Aug. 2023

Technical Newsletter

Removing fan from one HDD NVR

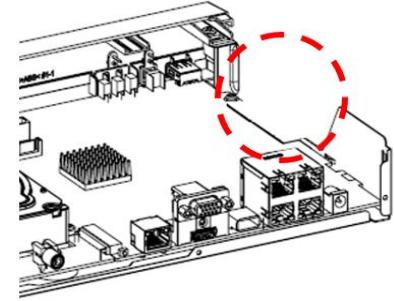
- To eliminate fan noise and A/S claims regarding the fan, the fan is removed from one HDD NVRs

[Before : Fan embedded on the left side]

[After : Fan removed]

Series	Model	FW for Fanless
X Series	XRN-420S	XRN-420S_5.01.52_230626172530 or later
Q Series	QRN-830S, 430S	QRN-1630S_5.06.52_230626173233 or later
A Series	ARN-810S, 410S	ARN-1610S_5.31.42_230626174111 or later
Pentabrid	HRX-434	HRX-435_4.52.32_230626172548 or later

- (1) **Remove fan and update F/W(MUST!)**

: Functions remain the same but only removed fan alarm feature

- (1) **Remove fan and update F/W(MUST!)**

. Fan connector is removed from new mainboard

3. Gore Vent applied models

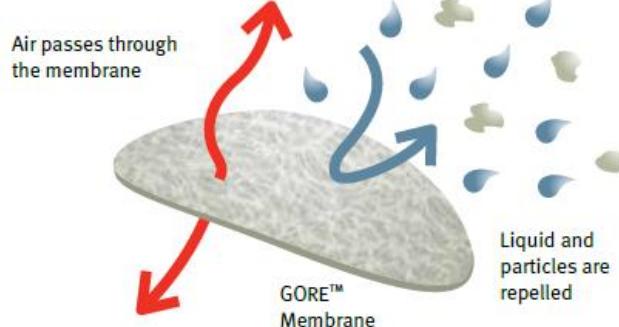
- By applying Gore Vent, product air permeability is increased to maintain internal and external pressure balance, prevent penetration of contaminated particles, and minimize condensation. Do not attach desicants to products applied with Gore Vent

3. Network(7) error occurs if HTTP is not 80 port

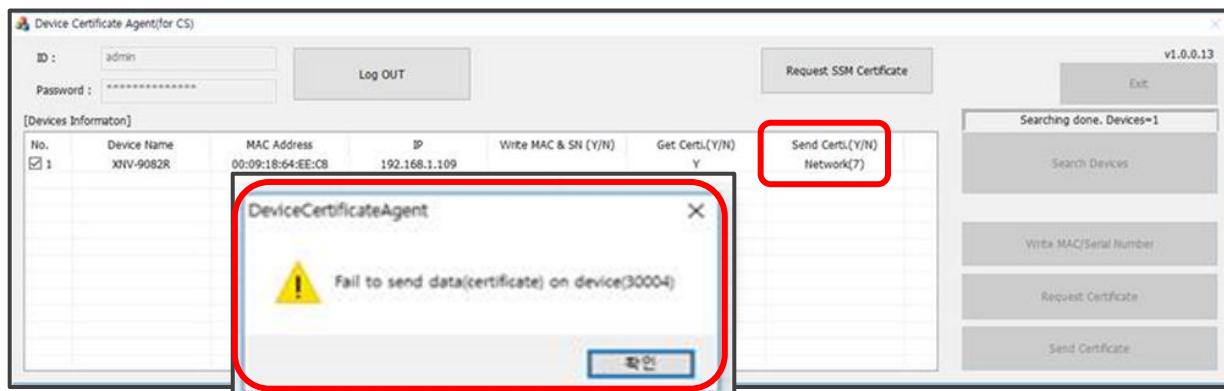
- . Network(7) error occurs with "Fail to send data(certificate) on device(30004)" message pop-up

- Reason for HTTP 80 port setting
 - . Device Certificate Agent S/W is developed as to work at HTTP "80 port"
 - When inserting device certificate, it links to its HTTP port by using SUNAPI protocol
- Setting guide
 - . Check if the device's HTTP port setting is '80 port'
 - . If HTTP port is different than 80, it needs to be changed as 80
